Town of Mammoth Lakes

Planning & Economic Development Commission Staff Report

AGENDA TITLE: Consideration of Major Design Review Application (DR) 24-004 for the revised Mammoth Arts and Cultural Center (MACC) project located in the Public/Quasi-Public (P/QP) zoning district. The project consists of the addition of an approximately 7,482 square foot performing arts theatre attached to the east side of the existing Edison Hall building located at 100 College Parkway. Pursuant to the California Environmental Quality Act (CEQA), the project was found to be consistent with the scope of development analyzed in the November 2023, Addendum to the Mammoth Arts and Cultural Center Initial Study/Mitigated Negative Declaration (State Clearinghouse No. 2019012023) which determined the revised project design would not result in any new environmental impacts that were not previously analyzed in the approved IS/MND.

FIGURE 2 - SOUTH ELEVATION

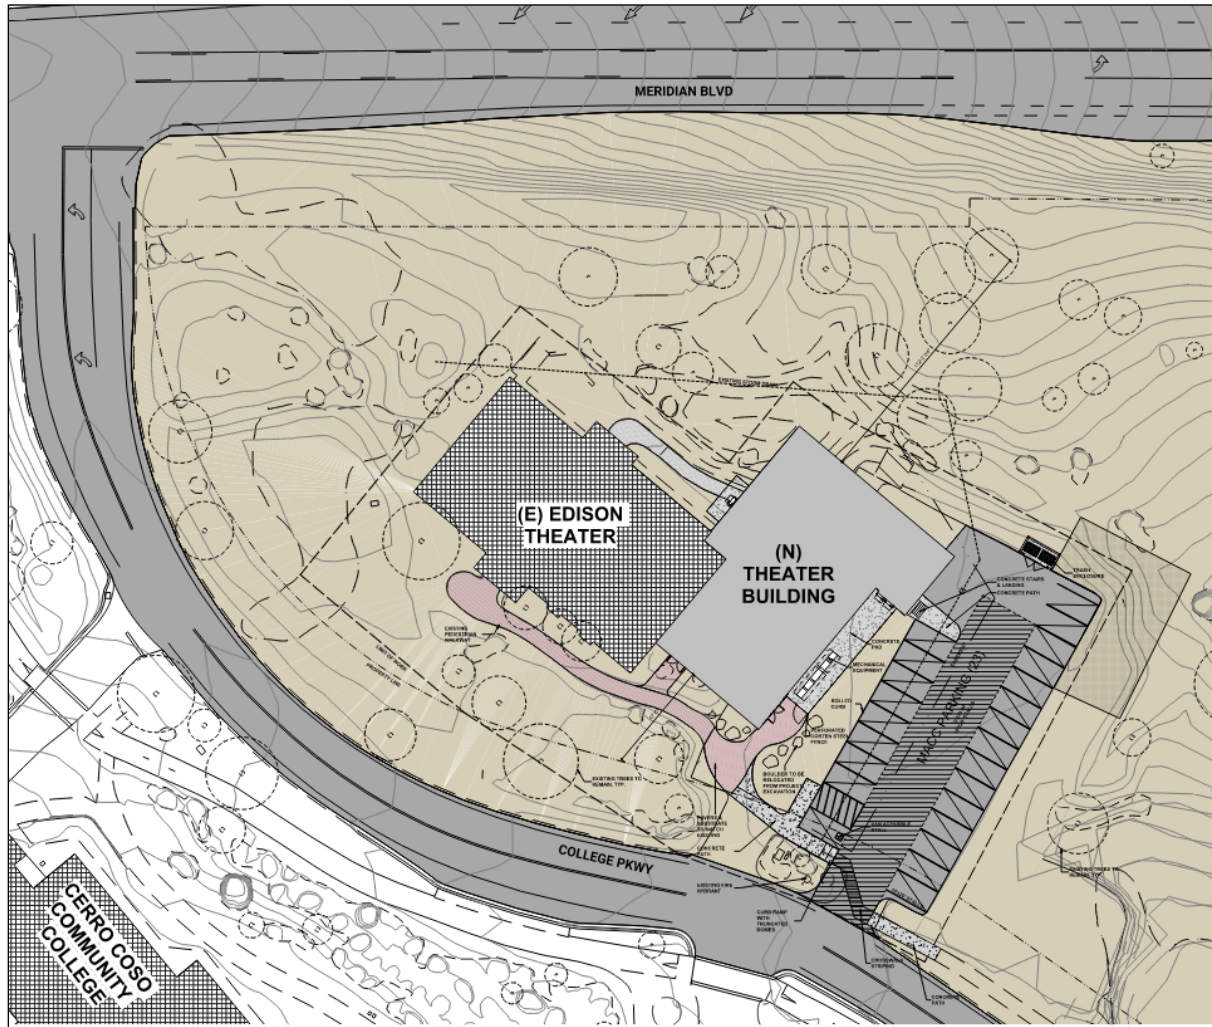
- Incorporate a more substantial width to the coping installed around the perimeter of the flat roof portion of the theatre building.
 - *Parapet flashing depth was increased.*
- Incorporate a darker CMU Block color for the northern section of the theatre building. This may also be beneficial above the shed roof on the south elevation.
 - *The CMU block material was changed to a darker earth tone and the concrete pilasters will be painted brown to match the color of the exterior doors.*

- Change the shed roof over the northeast corner pop-out to a gable roof design.
 - *The direction of the slope of the roof on the northeast pop-out was reversed so the two sloped roofs imply an offset gable. This also prevents snow shedding into equipment areas.*
